PRODUCT CHANGE NOTIFICATION

New Safety Certification

SmartFlex (P/N BB-SR3xx), **SmartMotion** (P/N BB-ST35x), **SmartSwarm** (P/N BB-SG30x)

Figure 1: Label Example #1

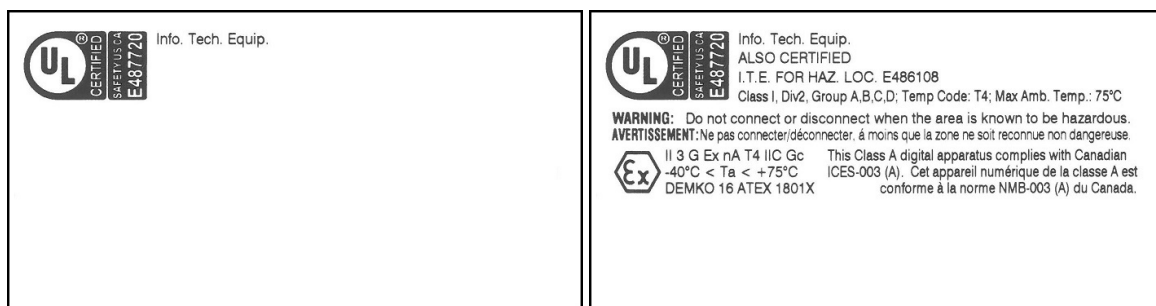
Anticipated impact on Fit, Form, and Function: There is no impact on the product itself. The only product change was made on the product label. Figure 1 shows a label for the device included in the new E487720 UL file. Figure 2 shows a label for the device included in the new E487720 UL file together with the existing E486108 UL file. The certification-related information was updated in product manuals and legislative documents as well.
